FIELD CHANGE DIRECTIVE No. 19

PROJECT: Truman Waterfront Park Phase 1A

OWNER: City of Key West	
OWNER's Project Number: GR0703/SE1505	
CONTRACTOR: Charley Toppino & Sons	Project Mgr.: Jim Bouquet
Description:	
Interactive Water Feature Upgrade	
	naterials and equipment to construct the upgraded he attached plans which are part of the revised Delta 10
Attachment: Drawings AE0.0 though AE0.6 (8 sh	eets) dated January 19, 2017
Do not proceed with this work until so authorized in wr	riting by the City.
Jim Bouquet, P.E. Director of Engineering	
Authorization to Proceed:	Jim Scholl, City Manager
Date:

PROPOSAL FOR: COMMERCIAL SPLASH DECK

AE.01.1

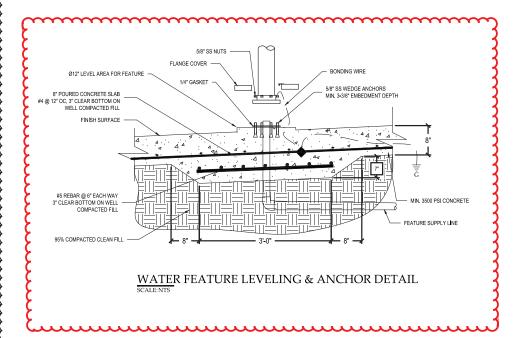
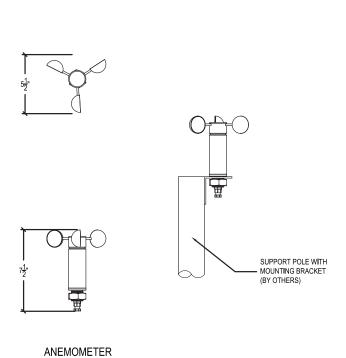
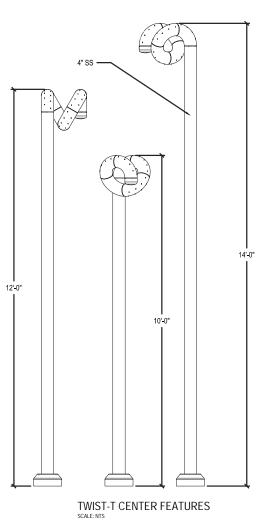
SUPPLY AND INSTALL ADDITIONAL REBAR REINFORCING AT "TWISTER " LOCATIONS(3) AE.01.1 AE.02 AE.03
